ND-17-0182  
10 CFR 50.90

Southern Nuclear Operating Company  
Vogtle Electric Generating Plant Units 3 and 4  
Request for License Amendment:

Engineered Safety Features Actuation Changes for Containment Vacuum Relief (LAR-17-005)

**Enclosure 2**

UFSAR Figure 7.2-1, Sheet 19 of 21

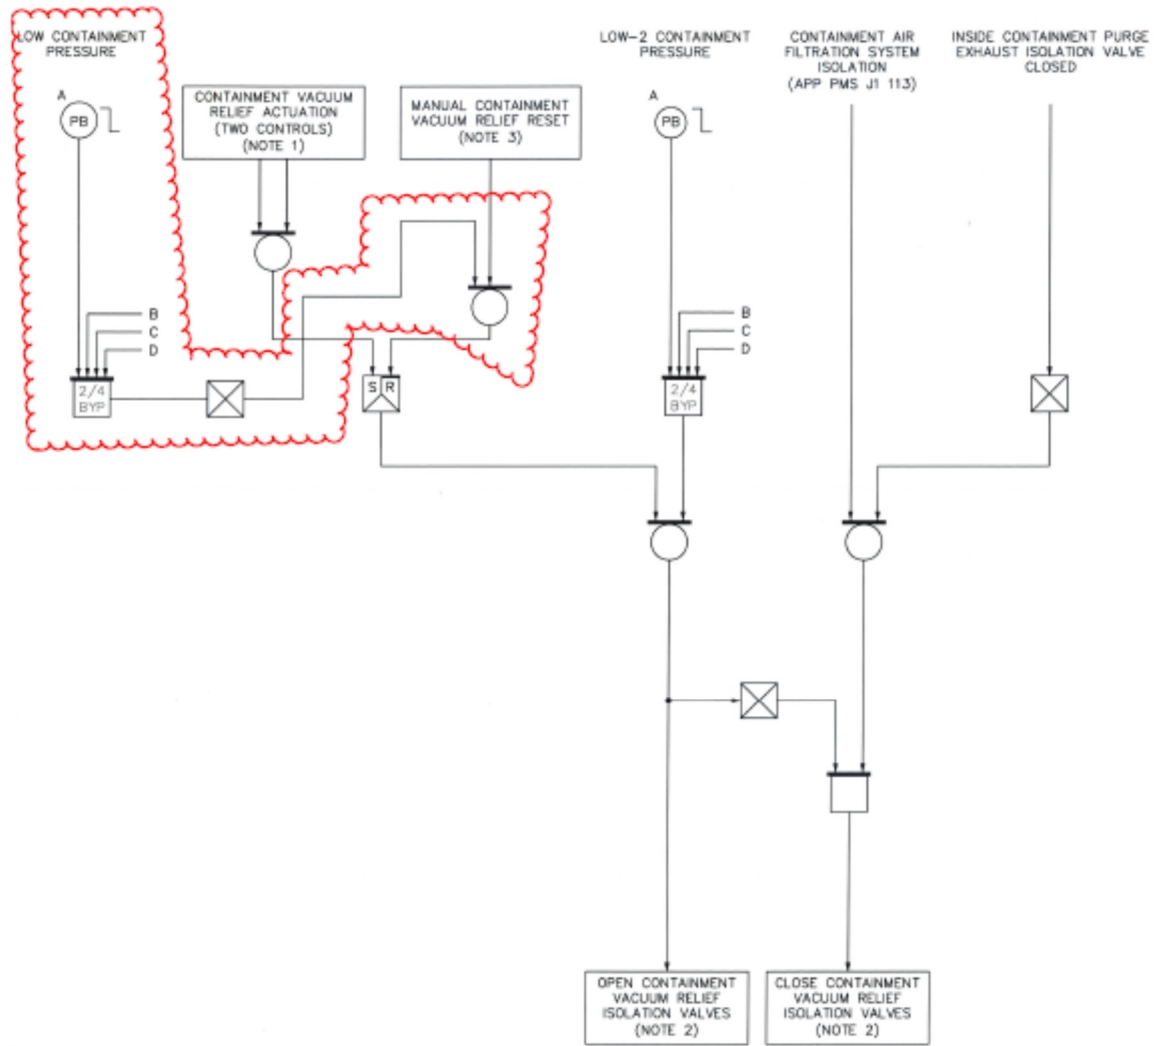
UFSAR Figure 7.2-1, Sheet 19	Revise to reflect the logic change to interlock the Low Containment Pressure signal with the manual initiation.
UFSAR Subsection 7.3.1.2.26	Revise to add description of the manual initiation interlock with two-out-of-four Low Containment Pressure logic and provide automatic reset of the manual initiation function.
UFSAR Table 7.3-1, Sheet 9	Revise Item 28.b - Containment Vacuum Relief, Manual initiation, to reflect a coincident interlock with the Low containment pressure condition.
UFSAR Subsection 9.4.7.1.1	Revise discussion to indicate that manual initiation can be actuated once the Low containment pressure signal is generated.

Added text is shown as Blue Underline  
Deleted text is shown as ~~Red Strikethrough~~  
Figure change is shown in red bubble
